Serial: RNP-RA/14-0124

H. B. ROBINSON STEAM ELECTRIC PLANT, UNIT NO. 2
DOCKET NO. 50-261 / RENEWED LICENSE NO. DPR-23

**RESPONSE TO REQUEST FOR ADDITIONAL INFORMATION ASSOCIATED WITH RELIEF
REQUEST (RR)-11 FOR RELIEF FROM VOLUMETRIC/SURFACE EXAMINATION FREQUENCY
REQUIREMENTS OF ASME CODE CASE N-729-1**

Figure 1. Plot of Crack Growth Rate (da/dt) versus Stress Intensity Factor (K_I) for Alloy 690 Data from Plate Material Tested by CIEMAT

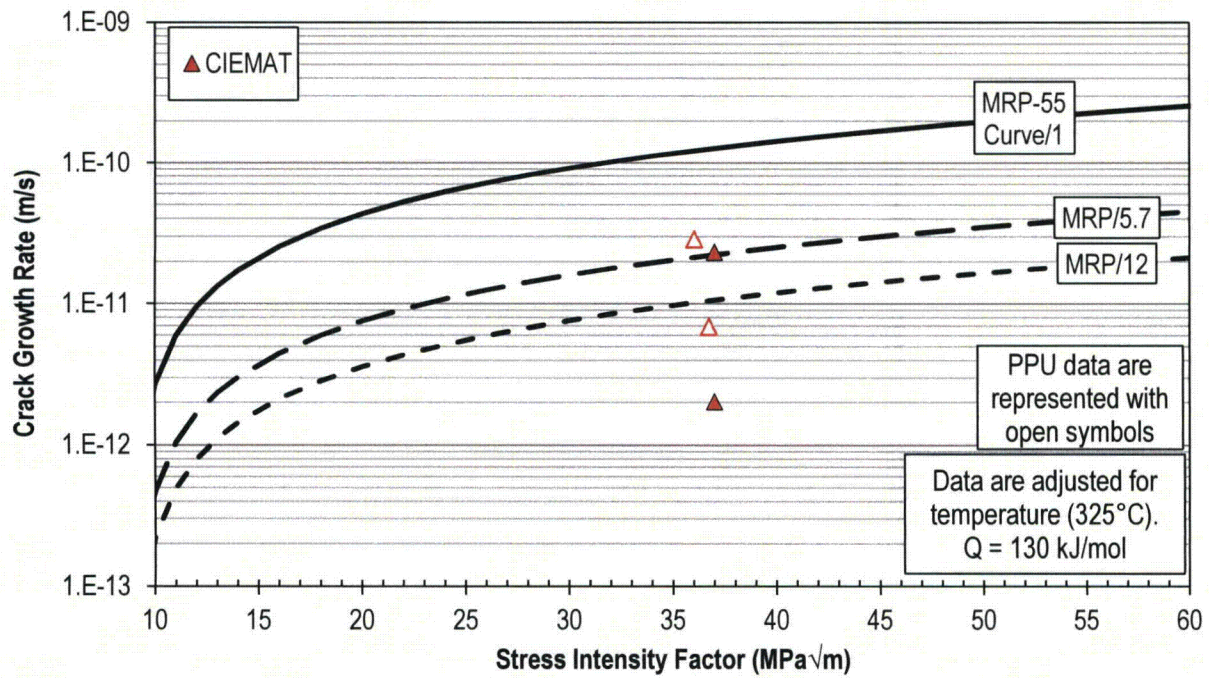
RAI 1

The licensee uses Materials Reliability Program (MRP) 375, "Technical Basis for Reexamination Interval Extension for Alloy 690 PWR [Pressurized-Water Reactor] Reactor Vessel Top Head Penetration Nozzles," to provide a technical basis for the proposed alternative. With regards to MRP-375, Figures 3-1, 3-3, and 3-5, provide a brief description of the materials tested for each plot that have data points above a hypothetical 5.7 factor of improvement line necessary to support the licensee's proposed alternative.

- Two of the points are from specimen 9ARB1, comprised of Alloy 690 plate material, loaded to $37 \text{ MPa(m)}^{0.5}$, and tested at 340°C and $15 \text{ cc H}_2/\text{kg H}_2\text{O}$ [7]. Both of these data are for the first half of segments that exhibited a crack growth rate that was an order of magnitude lower in the second half of the segment. A plot of crack growth rate versus crack-tip stress intensity factor (K) for the Alloy 690 data from MRP-375 for plate material tested by CIEMAT is provided here as Figure 1. These two points have minimal implications for the requested inspection interval extension for several reasons:

- As illustrated in Figure 1 and subsequent figures using open symbols, one of the two points was generated under partial periodic unloading (PPU) conditions. As discussed below in “Data Most Directly Applicable to Plant Conditions,” PPU conditions may result in accelerated crack growth rates that are not directly representative of plant conditions, especially for the case of alloys with relatively high resistance to environmental cracking like Alloy 690. The other data point obtained under constant load/K conditions is only slightly above the line representing a factor of 5.7 below the MRP-55 deterministic crack growth rate for Alloy 600.

Figure 22. Plot of da/dt versus K_I for Alloy 690 Data from Heat WP142

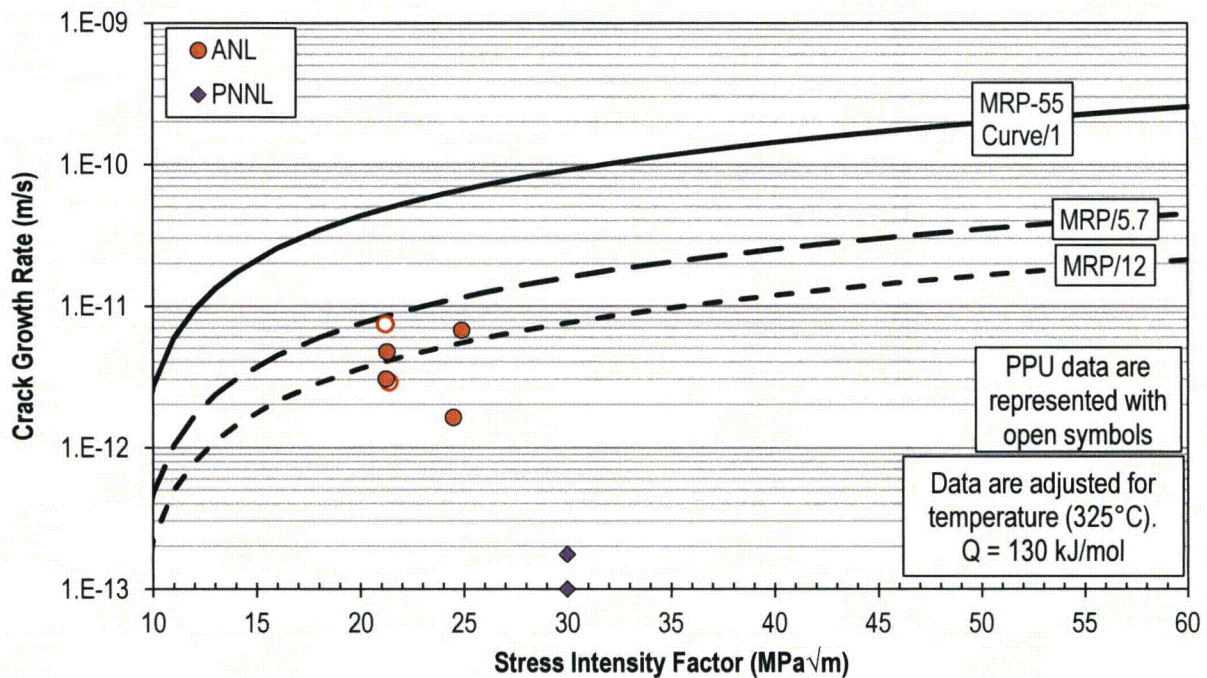
RAI 2

Provide any similarities between the items listed in (1) above and the associated nozzles and weld material used in the current reactor pressure vessel upper head at H. B. Robinson, Unit 2.

- In some cases, different laboratories have reported large differences in crack growth rate for the same material heat or test weld. This behavior is illustrated in Figure 4 for the Alloy 152 heat WC04F6 and Figure 22 for the Alloy 690 heat WP142. Thus, individual data points showing relatively high crack growth rates might not reflect the true susceptibility of particular categories of nozzle or weld material. Consistent data from multiple laboratories may be needed before one can conclude that a particular category of nozzle or weld material has an elevated susceptibility to PWSCC growth.
